**RESPONSE TO OBSERVATIONS  
(ABP-321454-24)**

**Brittas Wind Farm**

**Orsted**

**1 September 2025**

**Figure 6: Location of the Creamery and Thurles Water Tower Source relative to the proposed Brittas WF and Grid Route.**

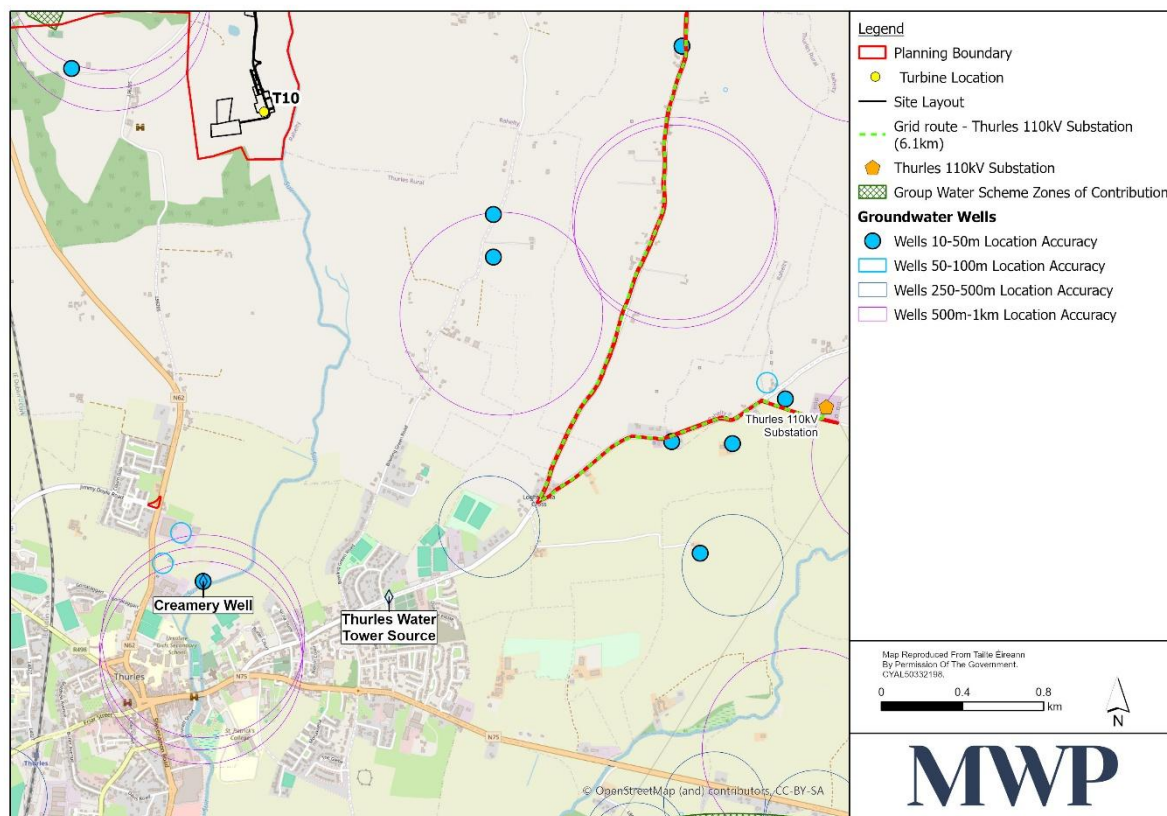
The applicant has not included any of the Uisce Éireann Public Supplies Table 9-9 & Figure 9-18, with particular reference to the Thurles Water Tower and Creamery Well groundwater supplies.

While section 9.4.3.7 of Chapter 9 (Water) in EIAR Vol. 2 has assessed the potential effects of the project works on groundwater and Local Well Supplies and found these to be slight, the earlier discussion of the local wells in section 9.3.5.3 did not specifically mention or profile the Uisce Éireann Creamery and Thurles Tower wells. As indicated in **Figure 10** below, the Creamery Well is located 2.36km south of the nearest Turbine (No,10) and is located adjacent to the River Suir. The Tower well is located 855m south-west of the nearest point of the proposed Grid route. Consequently, neither of these wells will be directly affected by the proposed works. Any potential indirect effects on water quality would be effectively mitigated by the standard water quality mitigation measures proposed in the EIAR and incorporated into the project design (see section 9.4.2 of Chapter 9 of the EIAR Vol. 2). These measures will effectively ensure that there is no significant effect on the local wells and their associated zone of consideration/abstraction.

During the construction phase, the grid route cable will be installed under existing road corridors and the proposed access tracks. Crossing a groundwater abstraction catchment with underground infrastructure carries potential risks, particularly where critical recharge zones or areas of high groundwater vulnerability are present. However, the cable trench will be narrow and shallow relative to the groundwater table at approximately 1.2–1.5 metres deep. Consequently, as the duration of these effects will be temporary, the magnitude will be low and the significance of the effects slight and indirect.

To manage these potential impacts, construction activities will be governed by the Construction Environmental Management Plan (CEMP), which will include site-specific pollution control measures such as hydrocarbon

bunding and emergency spill response protocols. Refuelling, plant maintenance and chemical storage will also be restricted to designated areas of the site compound. See sections 4.1.8 and 4.1.9 and EMP 2, EMP 3 and EMP 4 in the CEMP.

Figure 7: Map of Preferred Brittas Town Bypass Road extracted from the Thurles and Environs Local Area Plan 2024-2030

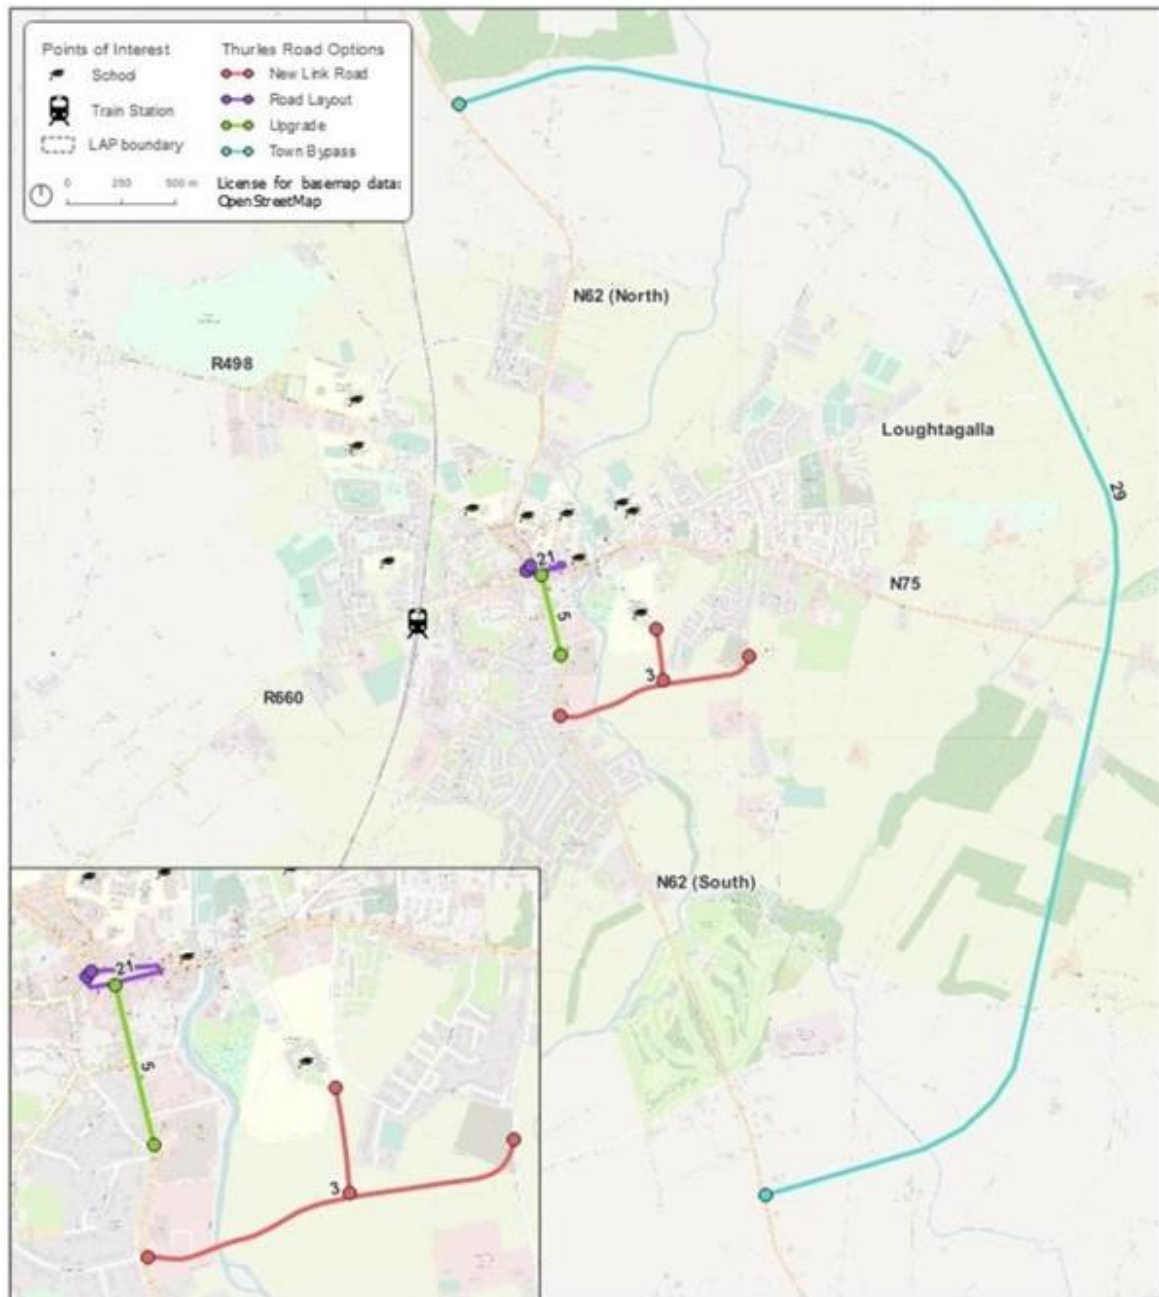
The route for the emerging preferred Thurles town bypass included in the Thurles and Environs Local Area Plan 2024-2030 (March 2024) (see map in Figure 6.17 below) runs along the southern boundary of the Brittas Farm and forests. The proposed road would bypass Thurles on the eastern side and would connect the N62 to the north and south with the N75 to the east of the town. At its closest point the proposed bypass would be around 615m south of Turbine 10 (the most southerly of the proposed turbines). This is well outside the fall distance for the turbine. The Brittas forests would also partially screen the turbines from the view of potential future road users.

This is just a proposal at this stage. There is no design or planning application lodged for the bypass. Construction of this would be likely to take place after the construction of the Brittas WF. Consequently, there is not expected to be any cumulative noise, water, flooding, population and human health, or land and soils effects.

**Appendix 3: Photomontage images taken from Holycross Abby towards the proposed Brittas Wind Farm**

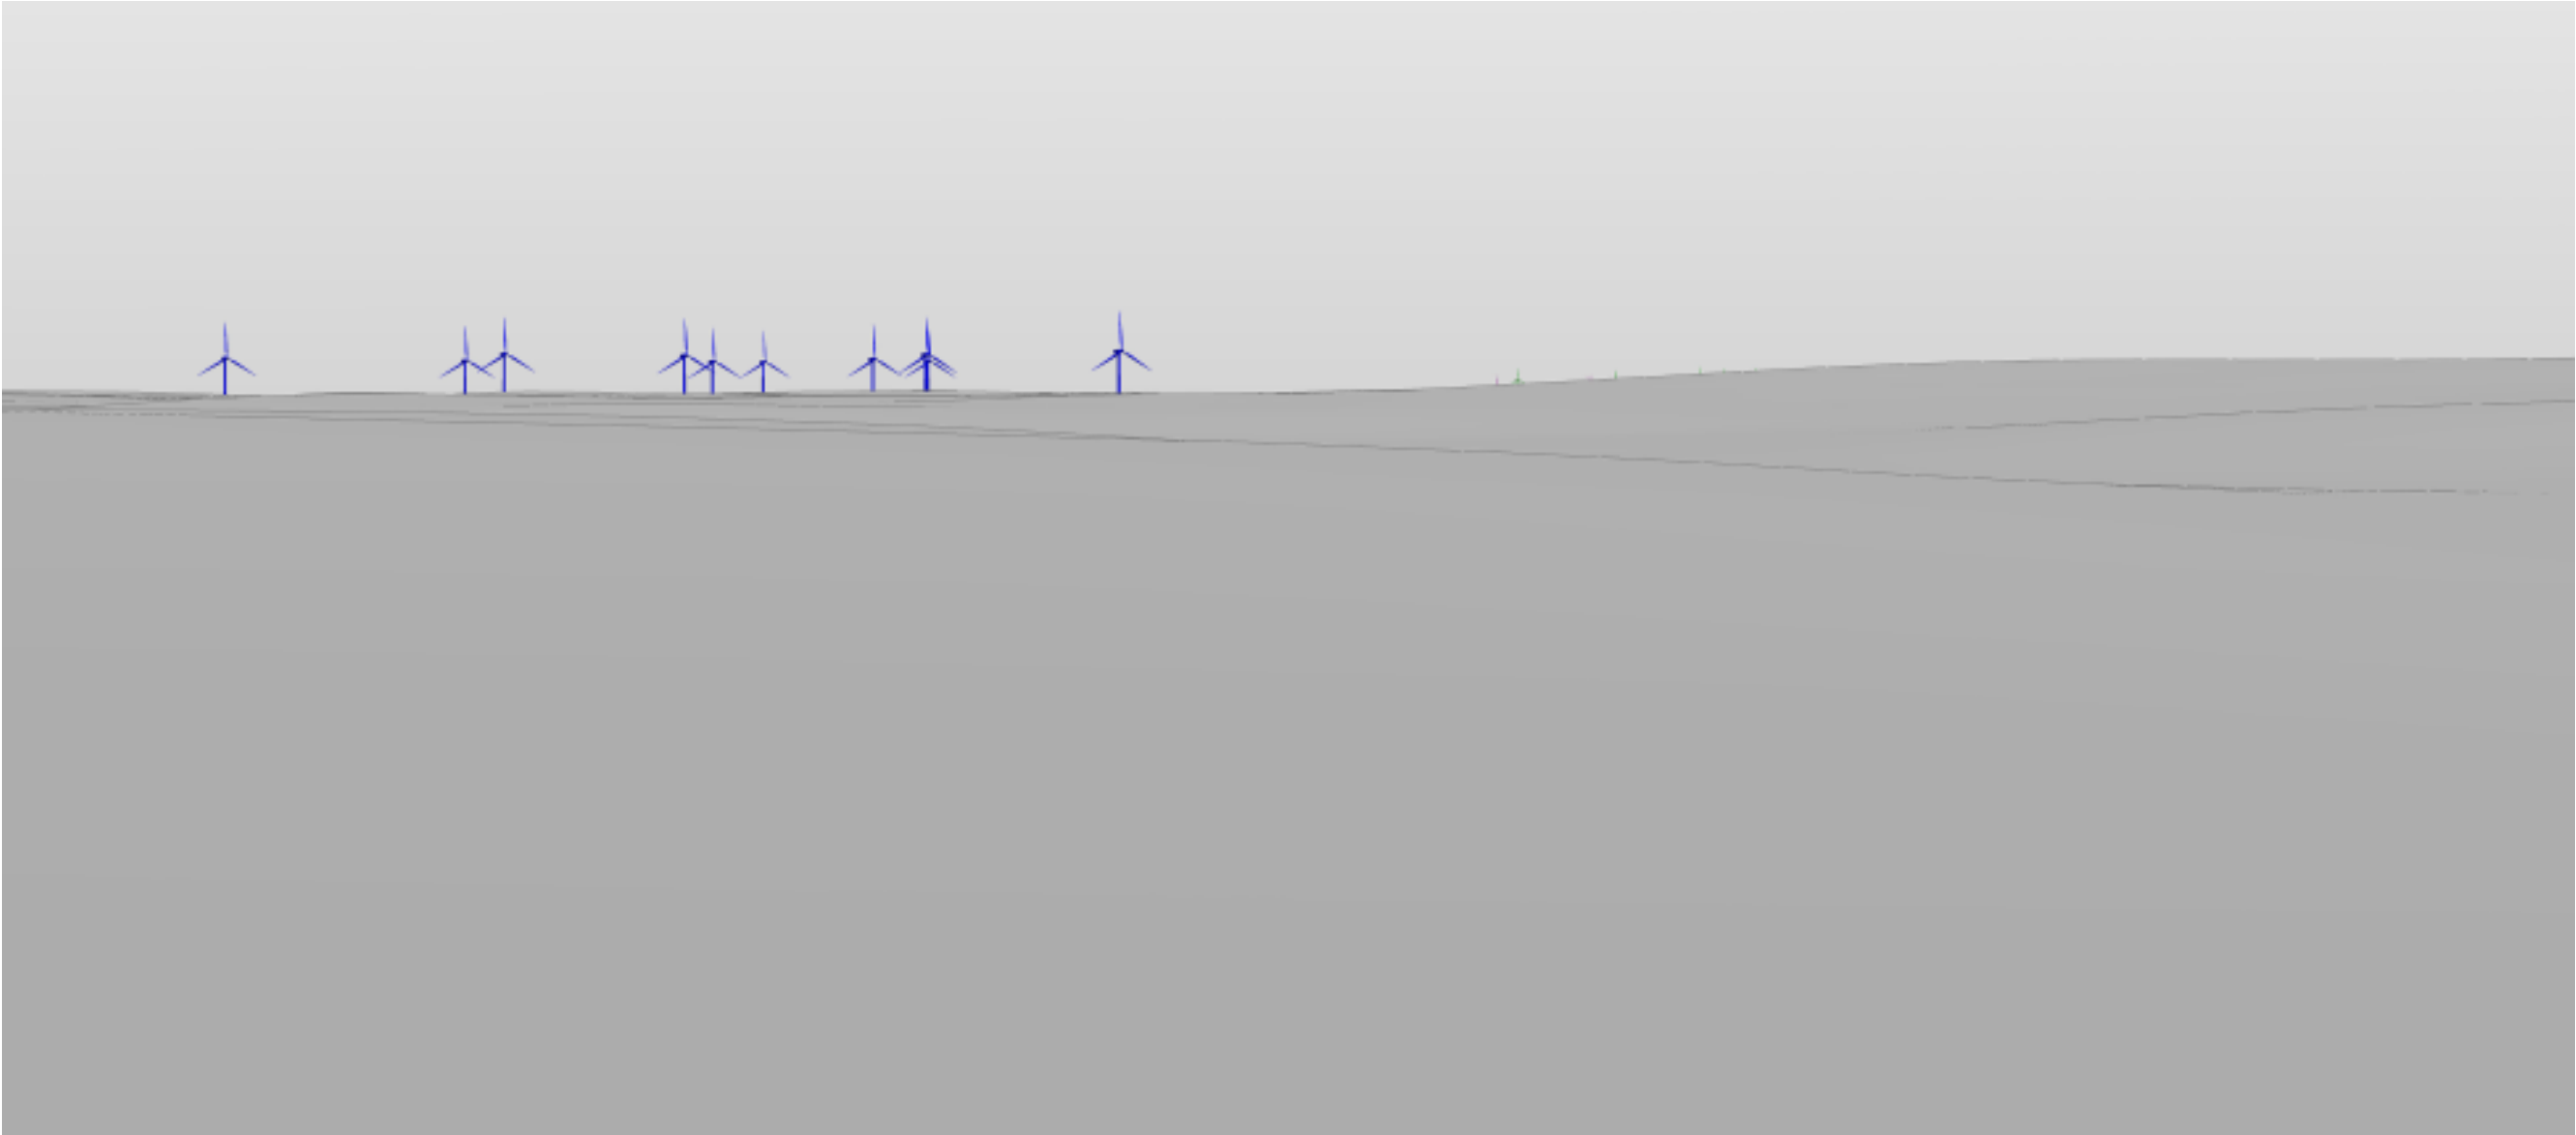
*The planning application assesses Viewpoint 14 (Holycross Abbey, NM No. 121) as a receptor of High- Medium sensitivity. The OPW is concerned that as the photograph was taken in the spring/ summer with full foliage and bloom, and that 'screening by the intervening vegetation/ buildings' may be less effective in the other 6 months of the year.*

The Holycross Abbey is located c.8km to the SW of proposed planning boundary and it is currently a significant tourist's attraction. The landscape in this area is relatively flat. Analysis of ZTV shows that all no 10 turbines will be theoretically visible from the location of the monument. However, results of the photomontage (see **Appendices 2 and 3**) revealed that this ecclesiastical site is surrounded by mature trees and houses. As the proposed turbines are below the height of the trees on the horizon, the turbines will consequently not be visible from the monument site during the summer when the trees are in full leaf and will be imperceptible in the winter. Considering this and the distance to the development, the likely cultural visual effect on the monument during operation phase is classified as not significant.
